91 BEATRICE CIRCLE

BELMONT, MA

ARCHITECTURAL DESIGN PRESENTATION

JUNE 10, 2021

SUMMARY OF REVISIONS

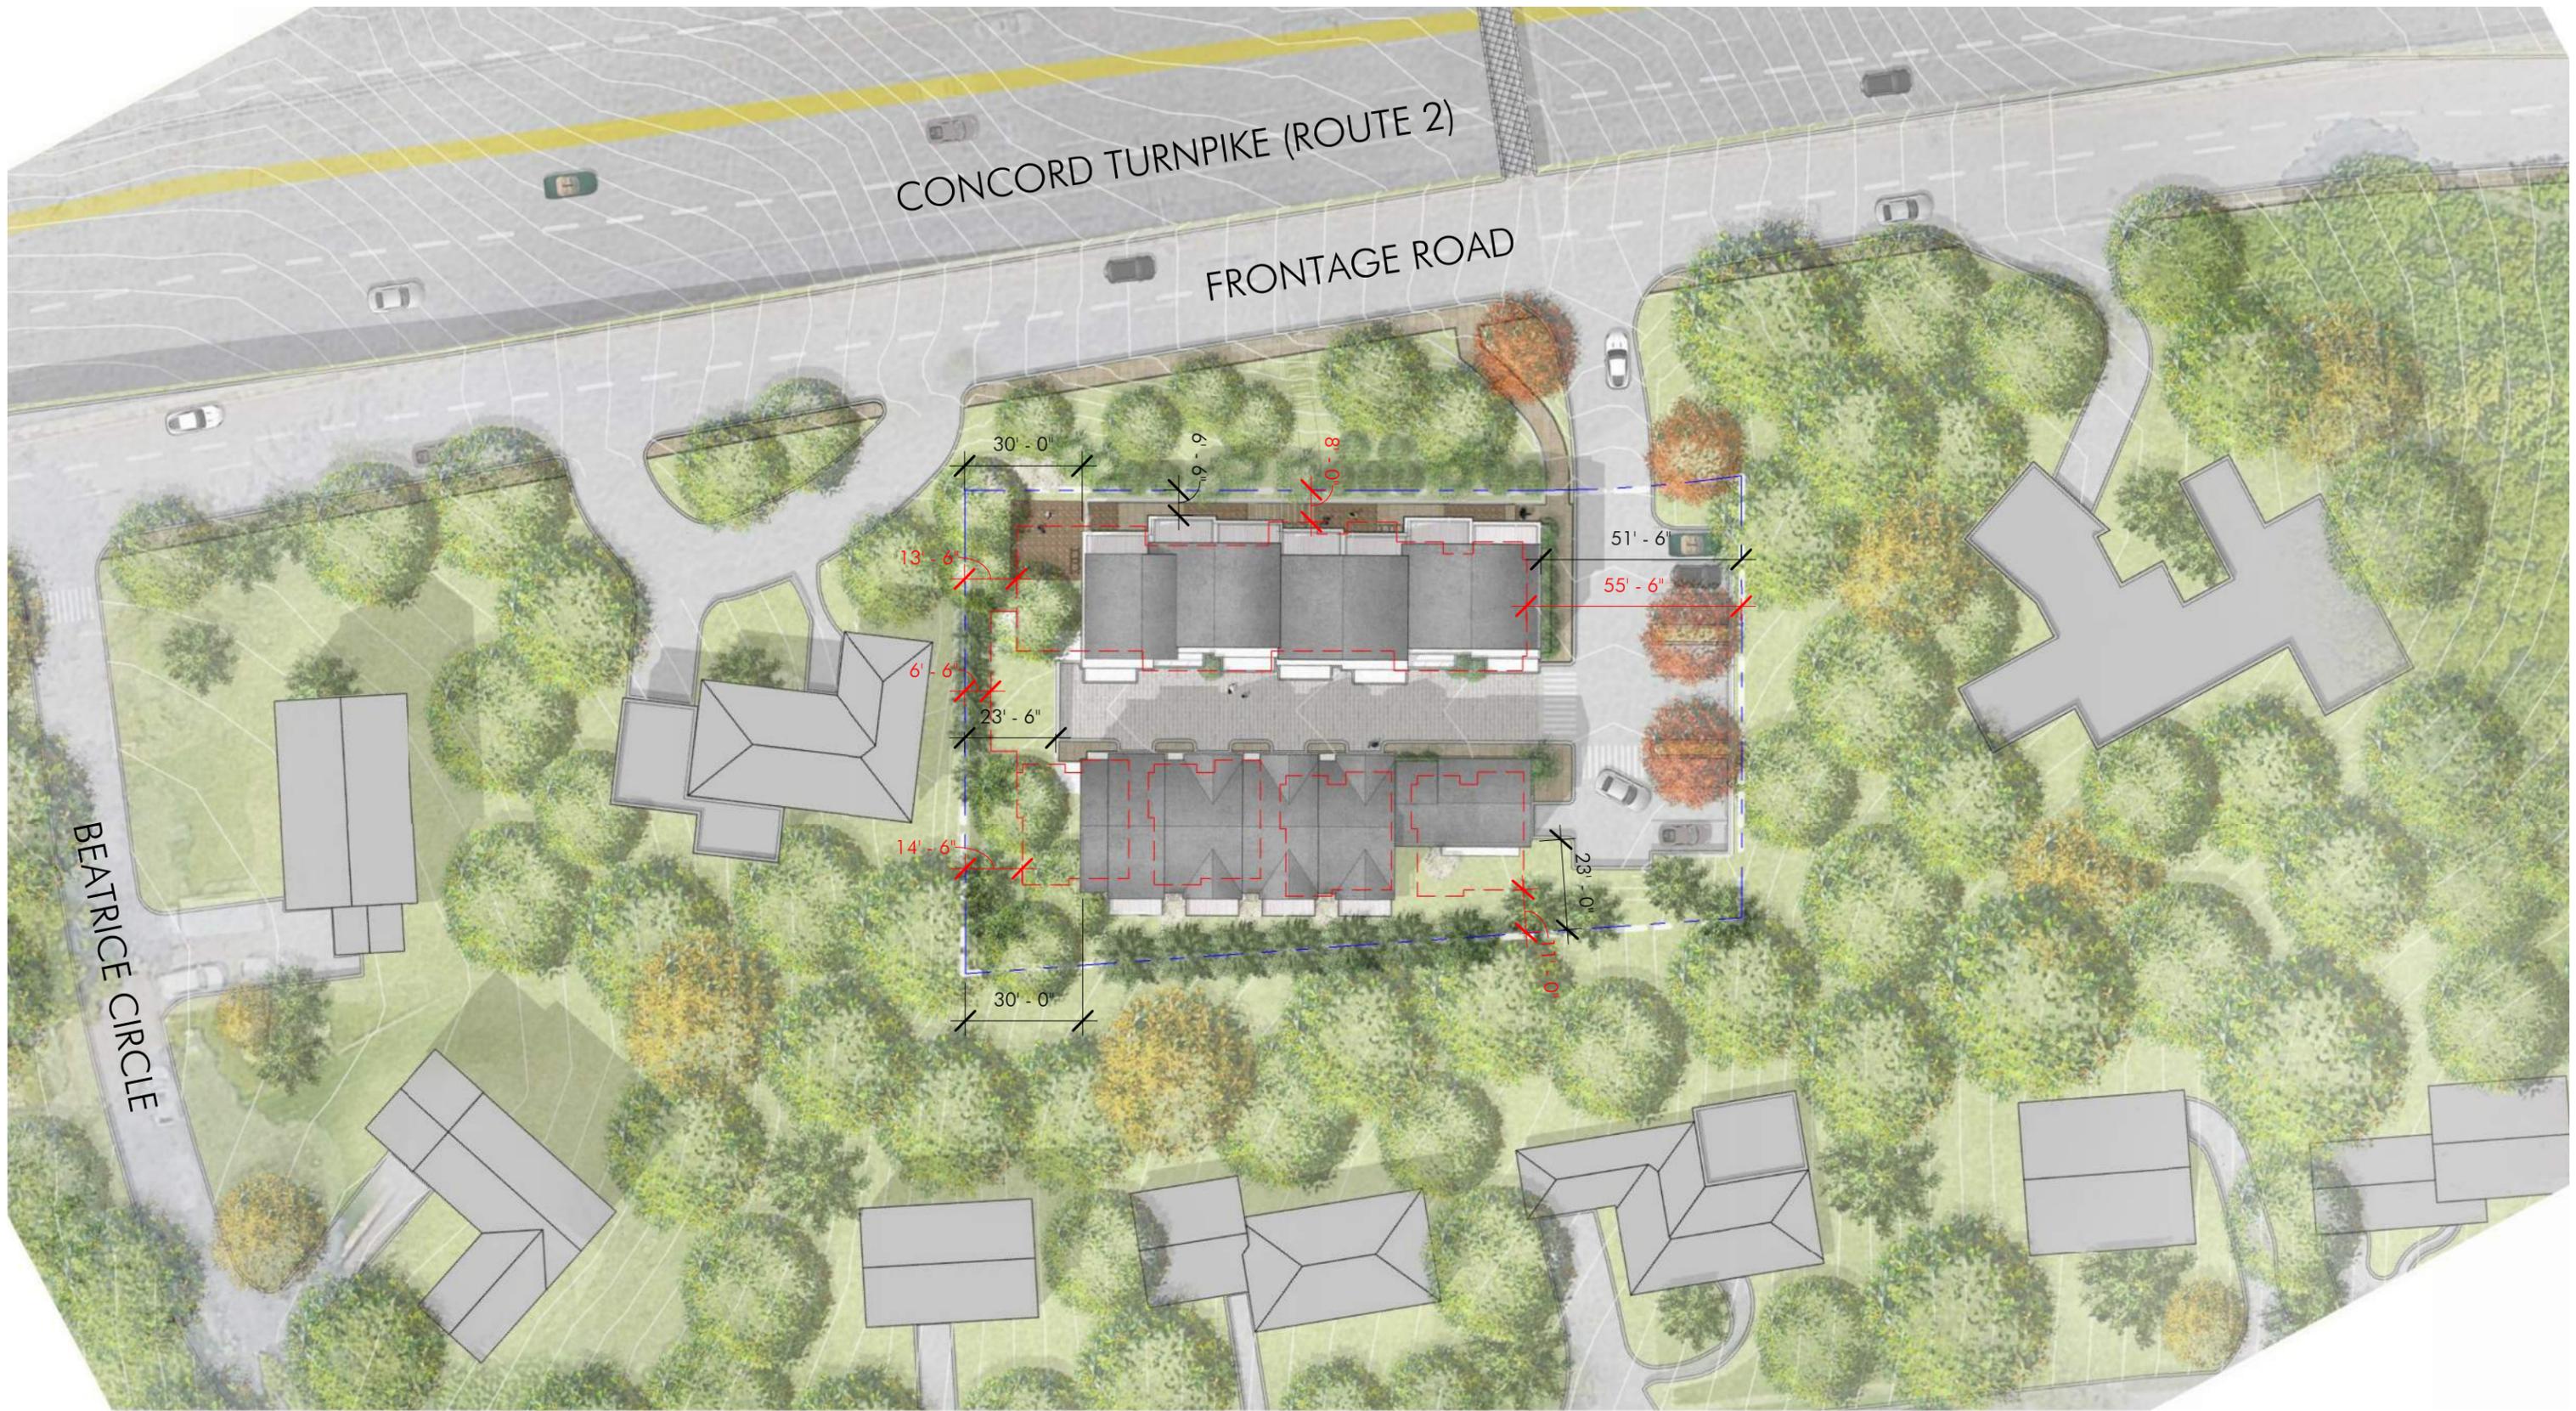
INCREASED SETBACKS

CONSOLIDATED DETACHED SINGLE-FAMILY HOMES AT REAR OF SITE INTO SECOND ROW OF TOWNHOUSES

RELOCATED END TOWNHOUSE UNIT AT NORTHWEST OF SITE TO REAR

SHIFTED DEVELOPMENT FOOTPRINT TO EAST AND NORTH

RECONFIGURED ENTRY SEQUENCE

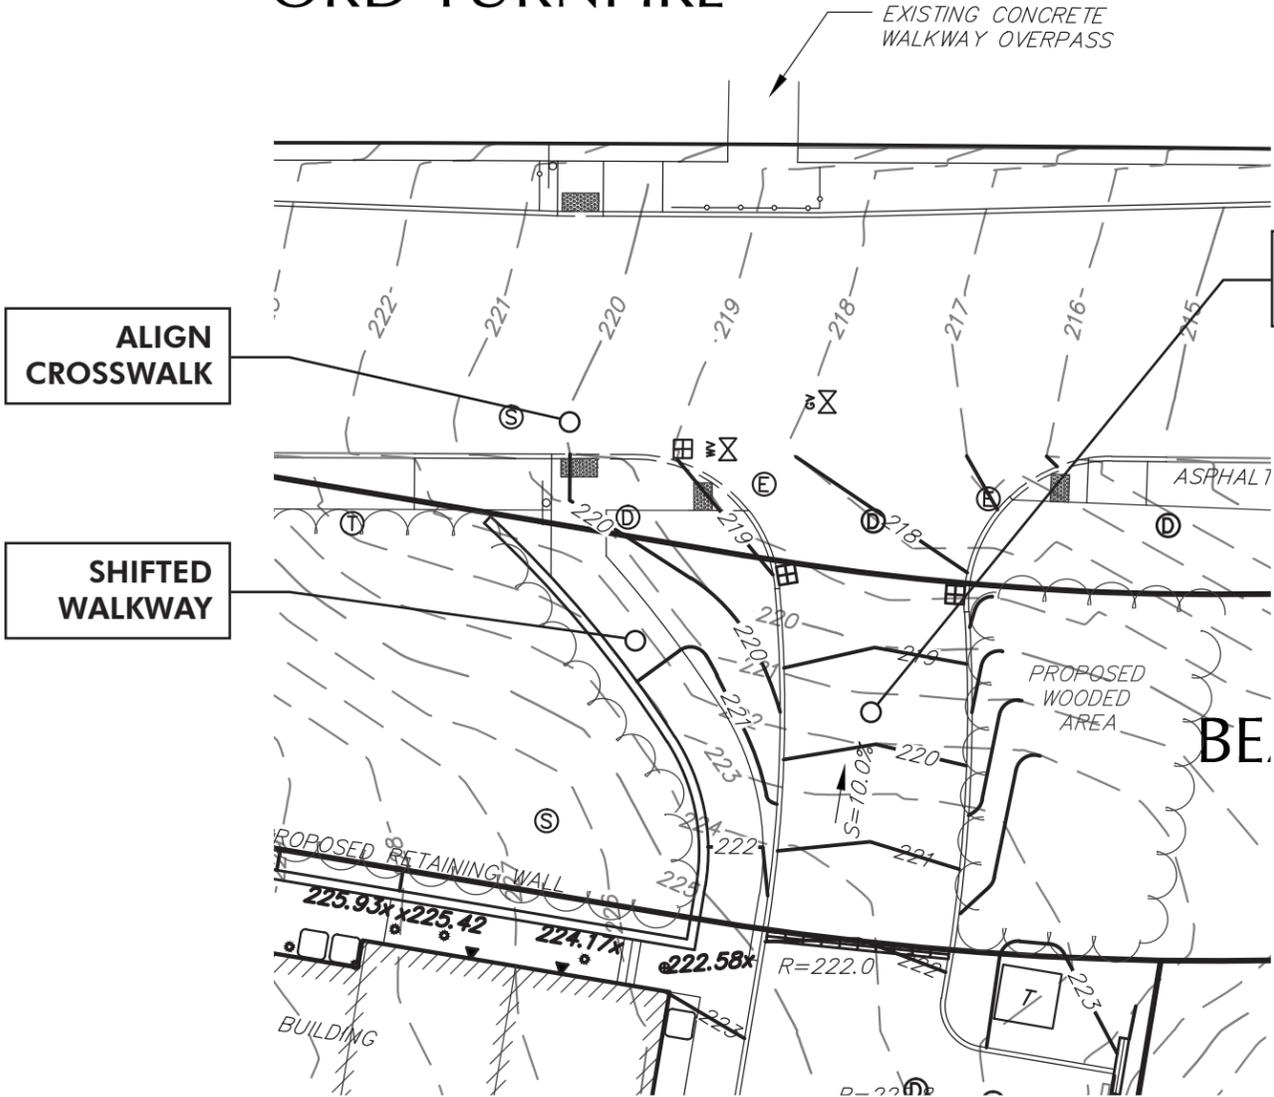
DRIVEWAY ROTATED TO MEET ROAD AT PERPENDICULAR ANGLE AND SLOPE REDUCED

WALKWAY SHIFTED UP THE SITE TO REDUCE AMOUNT OF DROP AND MAKE ACCESSIBLE

EXISTING VEGETATION AT CORNER CUT BACK TO IMPROVE VISIBILITY

PROPOSED RELOCATION OF EXISTING CROSSWALK TO ALIGN WITH NEW WALKWAY AND AVOID CONFLICT WITH DRIVEWAY CURB CUT

REDUCED DRIVEWAY SLOPE

INCREASED VISIBILITY
